City of Portland, Oregon
Bureau of Development Services
Land Use Services
FROM CONCEPT TO CONSTRUCTION

STAFF REPORT AND RECOMMENDATION TO THE DESIGN COMMISSION

CASE FILE: LU 16-170908 DZM
PC # 15-270567
205 NW 10th Ave | Modera Davis

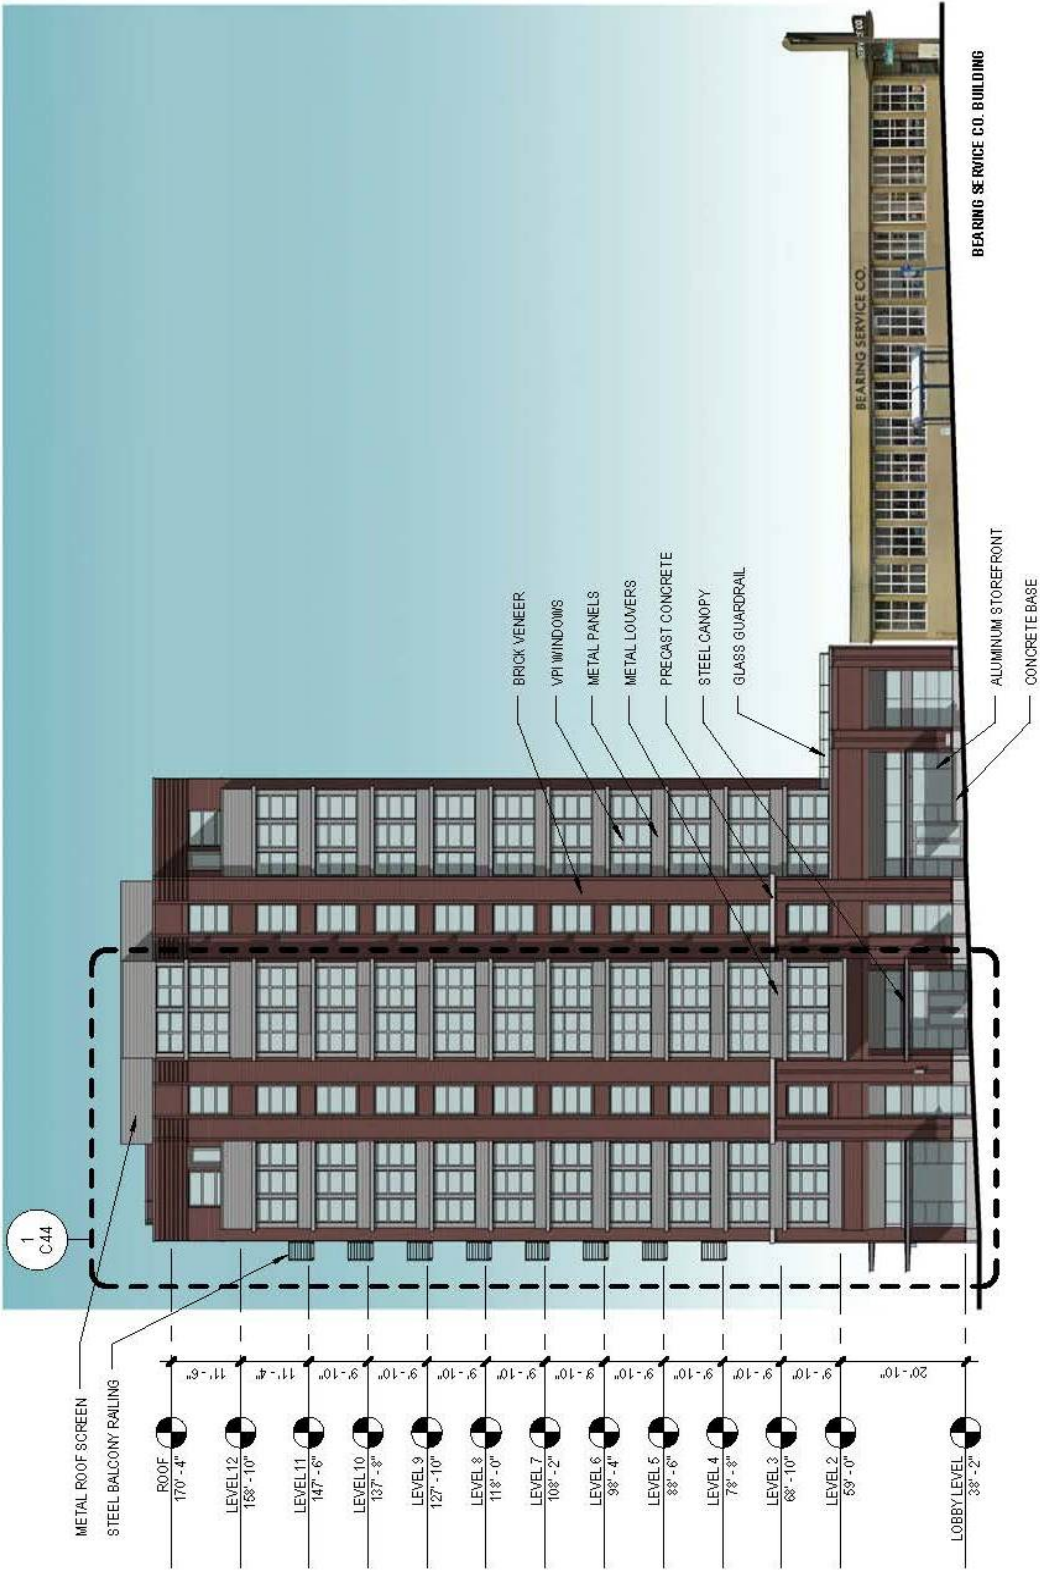
- *North/South Elevations.* The north and south elevations are composed of a series of interlocking columnar forms of differing size, program and material (glass/metal/brick) lacking a compelling sense of unity. These columnar forms are distinguished by programmatically derived planar shifts and height off-sets. The resultant visual effect is a collection of adjoined towers lacking any shared volumetric, material or color point of reference.

- *Ribbed Brick Detail.* A ribbed brick detail has been added to the capital of each of the pilasters in an attempt to better reference historical precedent. This addition appears conjectural as it is not germane to immediate context. It also visually conflicts with the patterning of the box-rib metal.
